**City of Surrey**  
**ADDITIONAL PLANNING COMMENTS**

**Application No.:** 7918-0425-00

**PROPOSAL:**

- Amend CD By-law No. 20061 to adjust the required parking rate for a proposed 6-storey apartment building consisting of 108 dwelling units.

drawing title:  
**SITE PLAN**

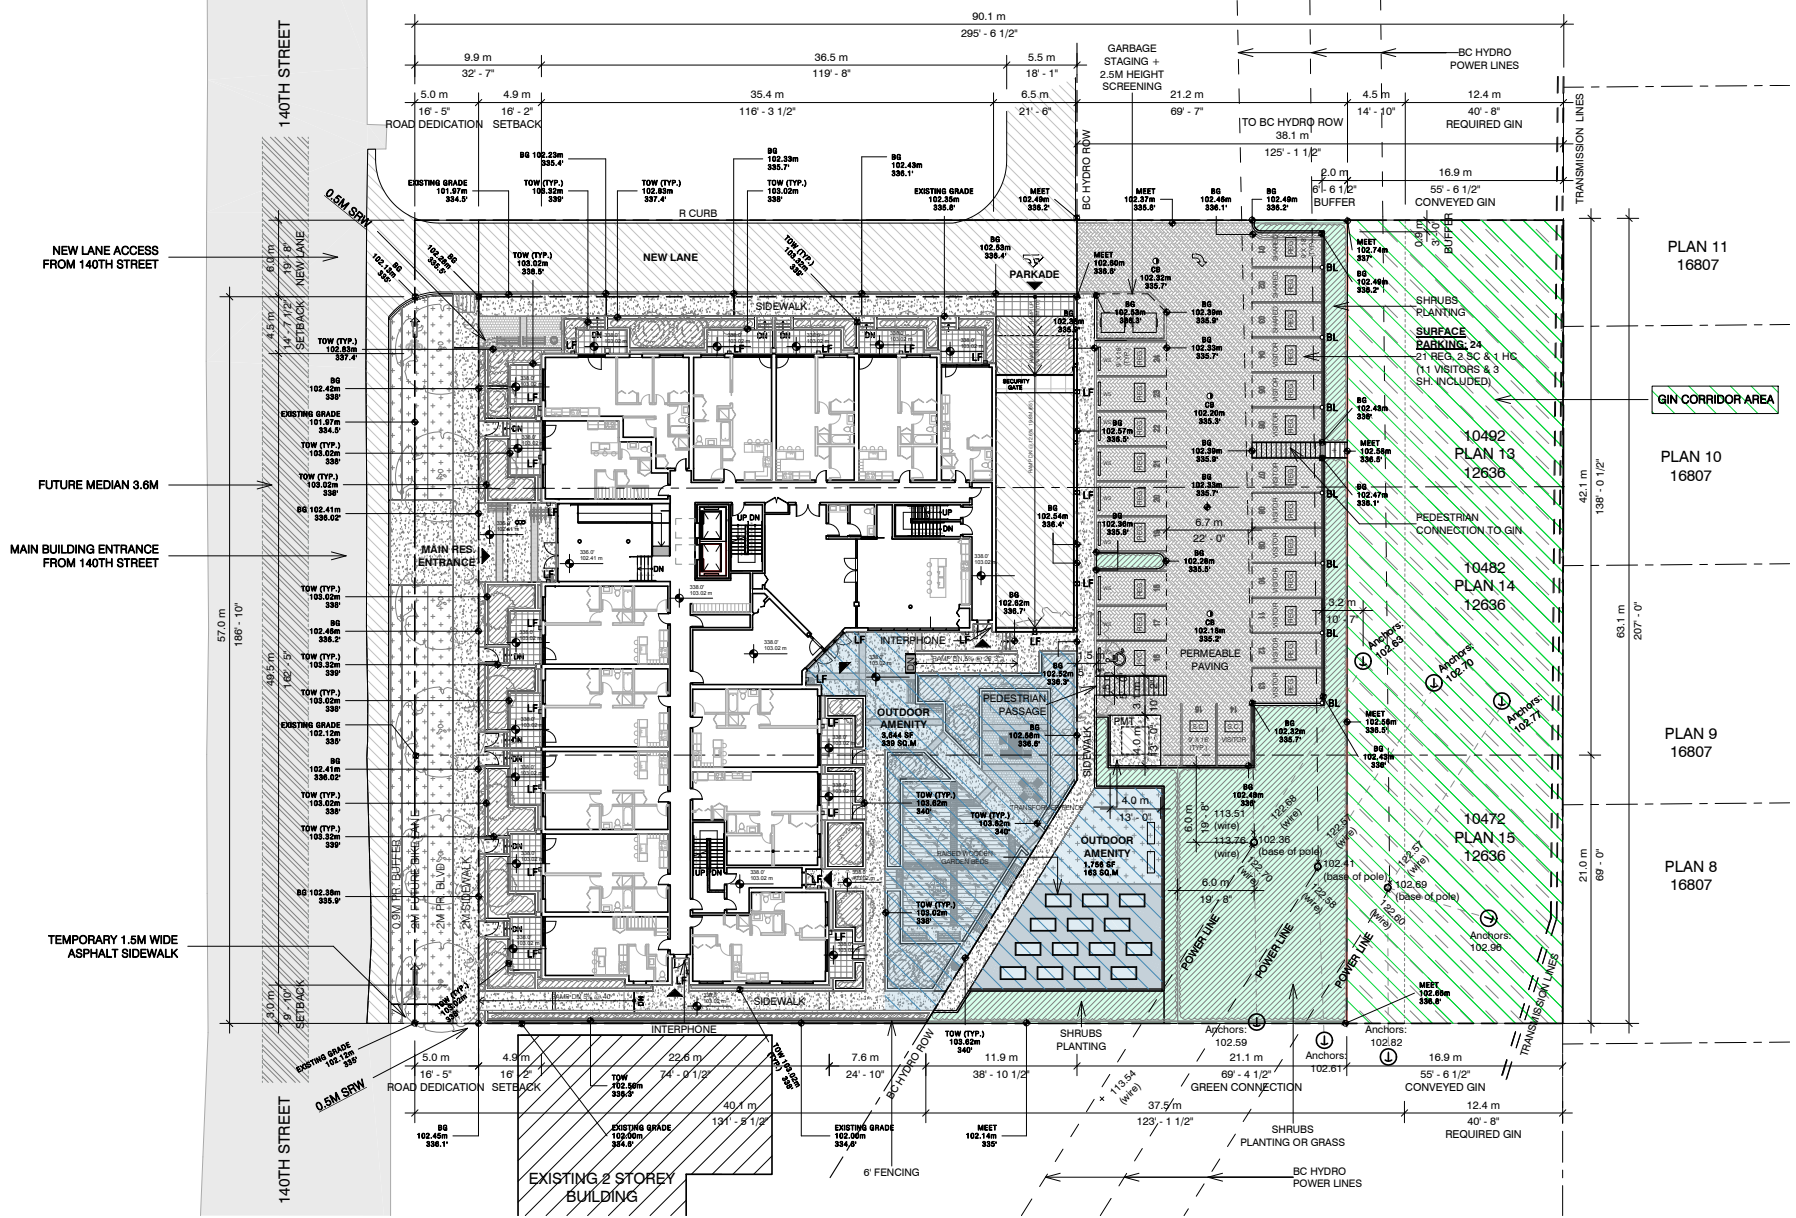
Outdoor amenity has been provided on BC Hydro ROW. This has been sent to Hydro and is pending approval (see Site Plan A1.1)
- 2. The discussion around proposed Sensitive Ecosystem Area for GIN corridor is under review, with ongoing discussions with respect to the extent of the area to be dedicated to the city. The required GIN corridor setback of 12.4m has been extended to 16.9m and the area will be conveyed to the city. (see Site Plan A1.1)*
- 3. Further minimizing the surface parking on the east side with more underground parking.*

- *Review the pedestrian and vehicular connectivity and movement around the site, and potential ROW easement to the southern neighbour.*  
A continuous accessible pedestrian path runs around the site further connecting to the Gin corridor at the southeast corner. (see Site Plan A1.1)

- *Recommend relocating at grade parking to the underground.*  
Five of the surface parking were relocated to the underground and that area used as part of the outdoor amenity. Ultimately, it can also provide a connection with the existing trail on the GIN corridor (see Site Plan A1.1).

- *Reconsider the laneway access to the adjacent site to the south.*  
South lane way access avoided to provide a green connection between outdoor amenity and GIN corridor (see Site Plan A1.1).

- *Consider a connection to the play area from seating to the east next to the surface parking.*  
Connection to the play area provided at the east/south side of the property (see Site Plan A1.1).

The underground parking level has been revised. Surface parking has been minimized by providing more u/g parking stalls. Based on ADP comments and discussions with planning, the laneway access to the adjacent development will not be implemented at the time the development is constructed. (see Site Plan A1.1)
- 4. The surface parking and the 50m GIN corridor interface.*

A 2m landscaped buffer is provided between surface parking and GIN corridor. A 1.2m fence delineates the boundaries of the GIN corridor. See landscape and Site Plan A1.1
